Service Advisory

CC-610A

iSERIES

Subject: **Proper Adjustment Of The Drive Engage Rod and Ferrule.**

FIGURE 3

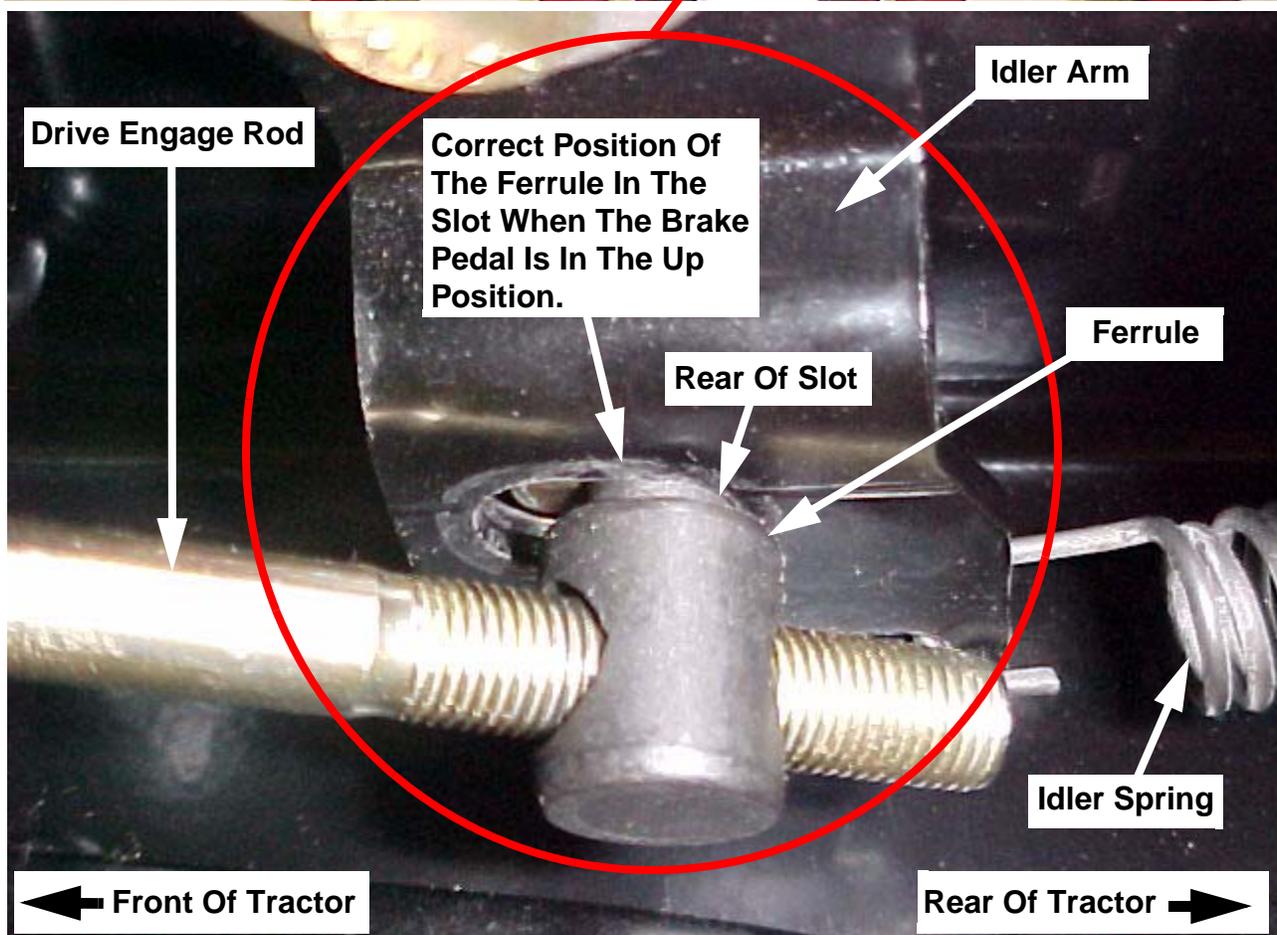
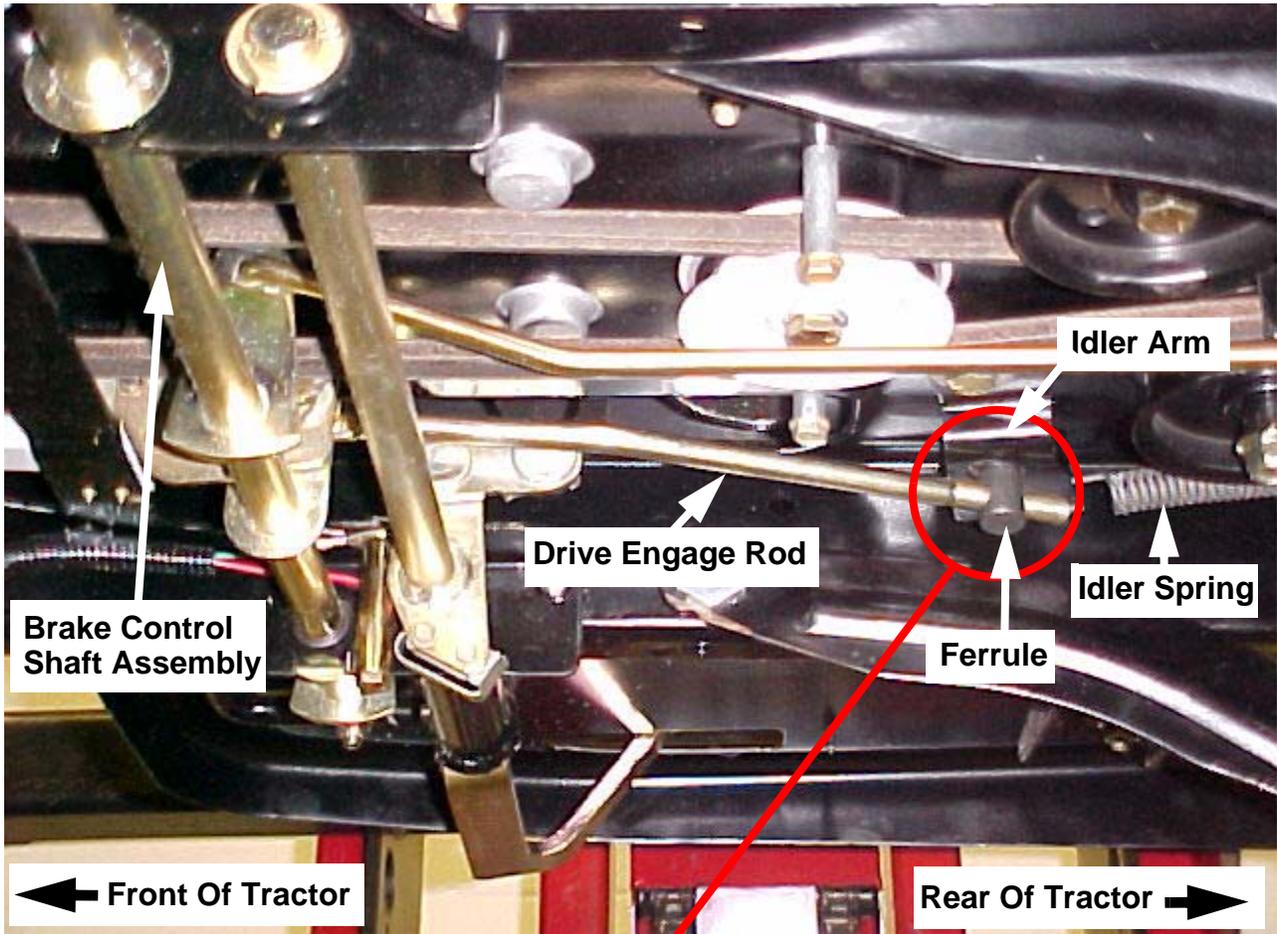
9. Check the left and right Transmission Pulleys for wear or damage.
10. Check that all Belt Guides are in place.
11. If any pulley's are found to be worn or damaged, it's recommended to replace all pulley's and belt to assure that a failure doesn't happen at a later time from a worn pulley or belt that was not replaced.
12. Install the P.T.O. Clutch. Torque the retaining bolt to 450-600 in. lbs (37.5-50 ft. lbs.).
13. Check the Drive Engage Rod for proper adjustment. The Ferrule needs to be to the rear of the slot in the Idler Arm when the Brake Pedal is in the up position. If the Ferrule is not set to the rear of the slot in the Idler Arm, the Drive Engage Rod needs to be adjusted in the Ferrule. See Figure 3 for the proper orientation of the Ferrule in the slot of the Idler Arm.

FIGURE 4

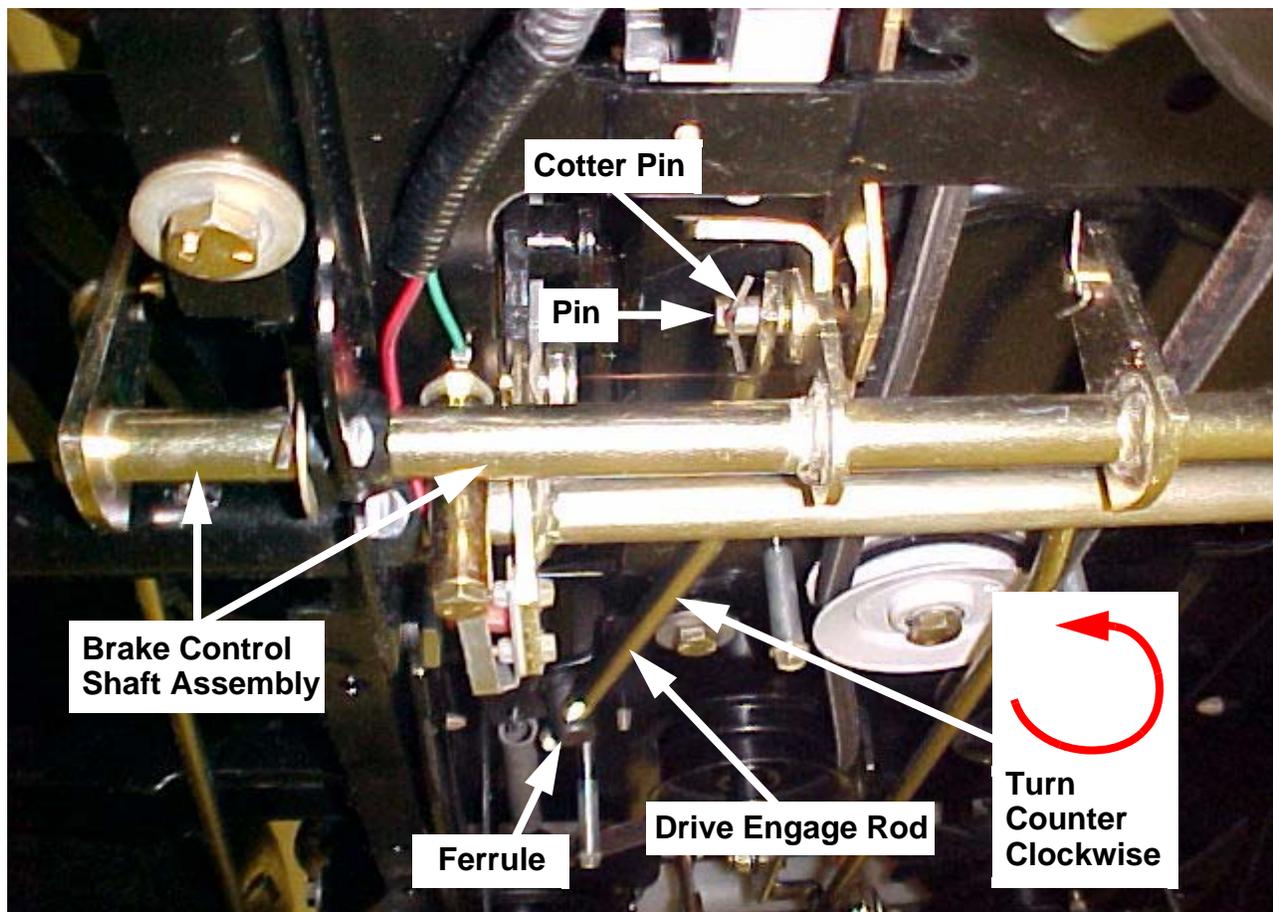
14. Remove the Cotter Pin which secures the Drive Engage Rod to the Brake Control Shaft Assembly. See Figure 4.
15. Remove the Drive Engage Rod from the pin of the Brake Control Shaft Assembly. See Figure 4.
16. Turn the Drive Engage Rod counter clockwise in the Ferrule, to position the Ferrule to the rear of the slot in the Idler Arm Assembly. With the Brake Pedal in the up position adjust the Drive Engage Rod in the Ferrule until the Ferrule is positioned to the rear of the slot and the Drive Engage Rod slips onto the pin of the Brake Control Shaft Assembly.

FIGURE 5

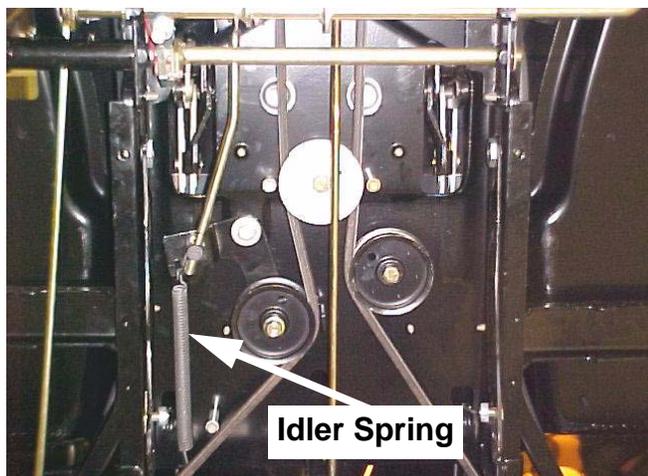
17. Unhook the Idler Spring from the Idler Arm, then unhook the Idler spring from the hole in the frame. After removal, discard the Idler Spring. See Figure 5.

18. Install the new Extension Idler Spring (732-04579), in the reverse order the old Idler Spring was removed.
